May 3, 1985
JPN-85-40

Subject: James A. FitzPatrick Nuclear Power Plant
Docket No. 50-333
Containment Vent and Purge Valve Operability

SYSTEM 20" & 24" CONTAINMENT PURGE/VENT VALVE QA CAT. 1
SUBJECT 20" & 24" CONTAINMENT PURGE/VENT VALVE LOAD CARRYING CAPACITY ANALYSIS

24" VALVE TAG # 27A0V-111, 27A0V-112, 27A0V-113

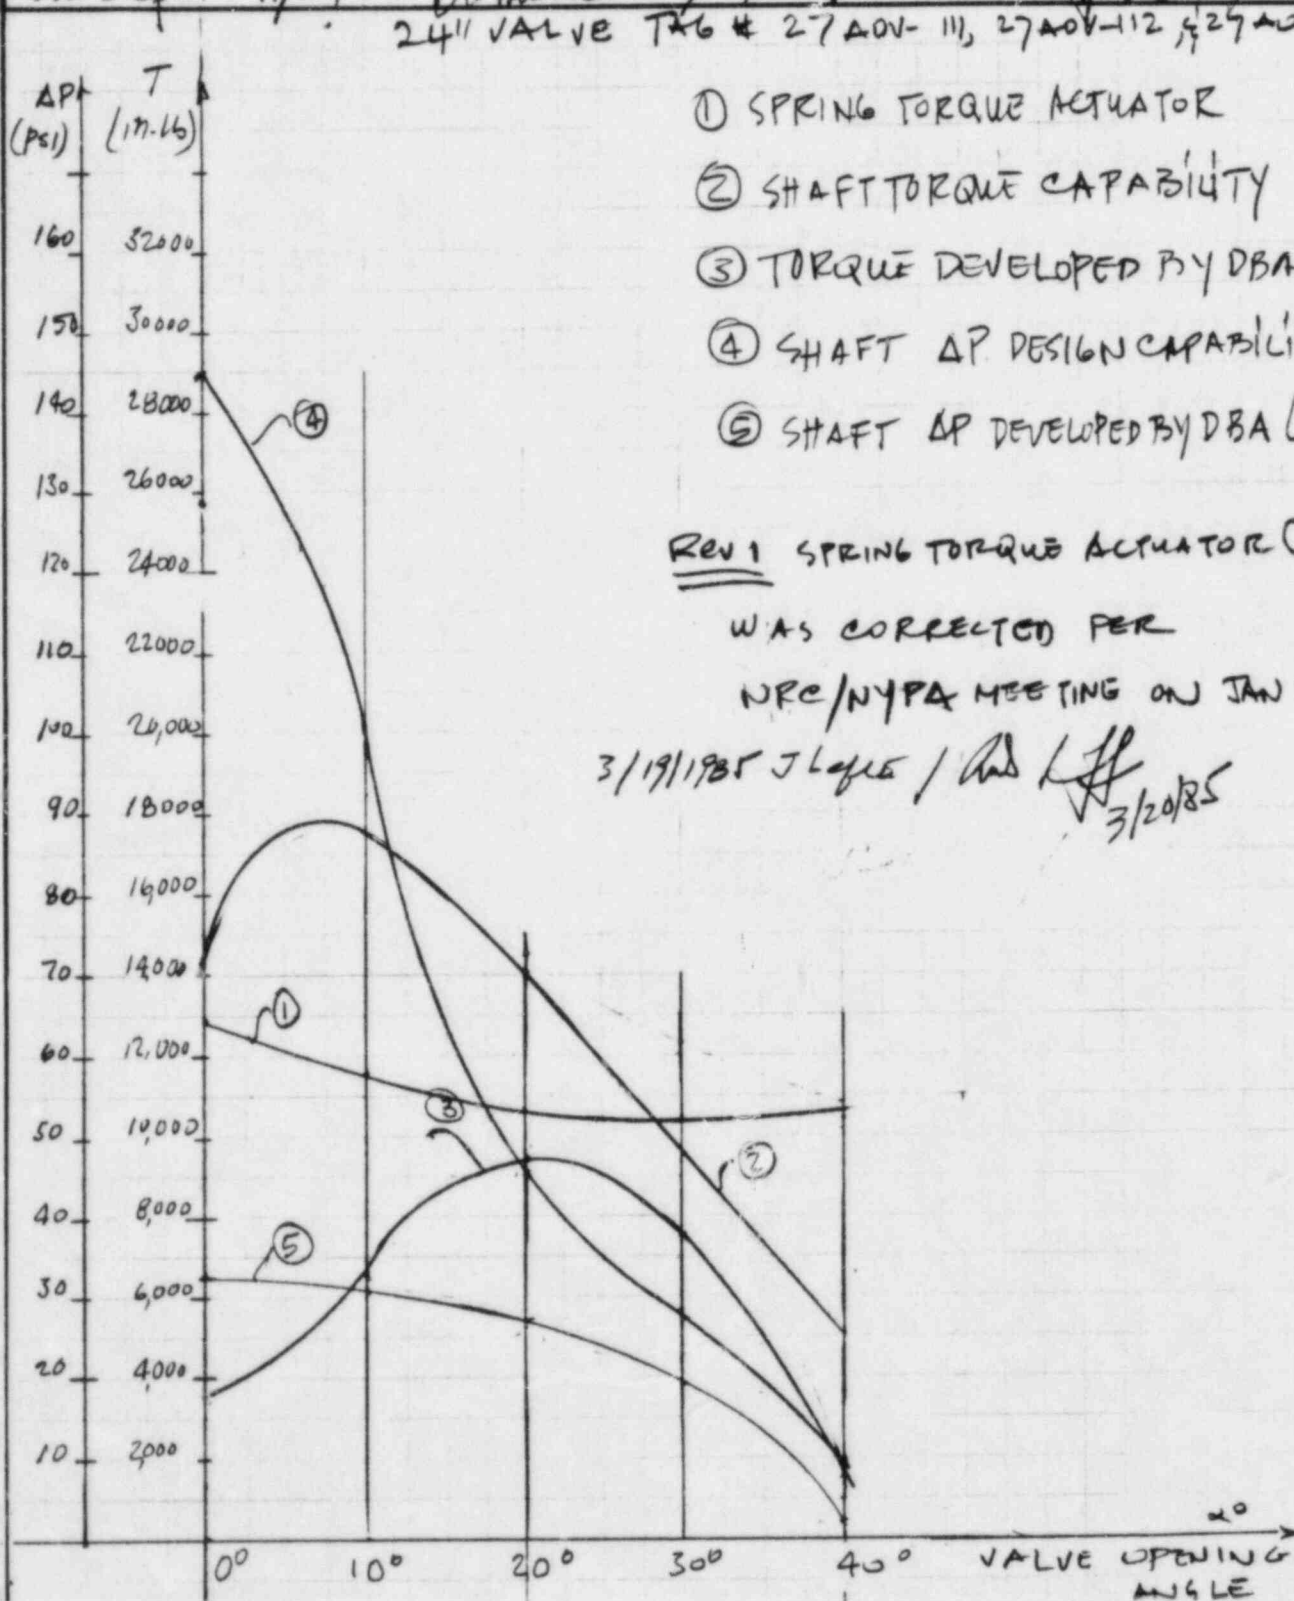
REV 1 SPRING TORQUE ACTUATOR ①

WAS CORRECTED PER

NRC/NYPA MEETING ON JAN 23, 85

24" VALVE TAG # 27 AOV-11A

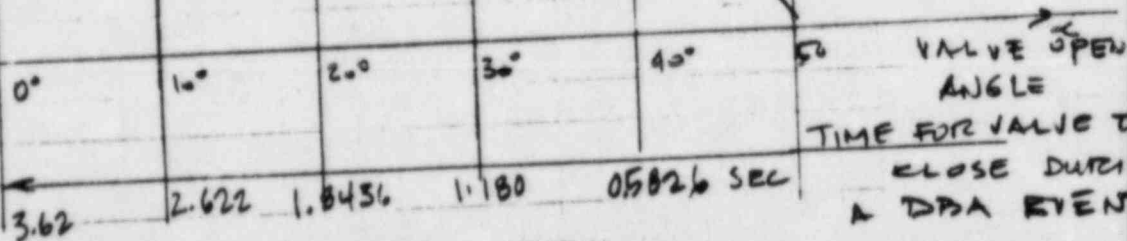
REV 1 SPRING TORQUE
ACTUATOR ①

3/19/1985 CORRECTED PER
URC/NYPA MEETING
ON JAN. 28, 1985
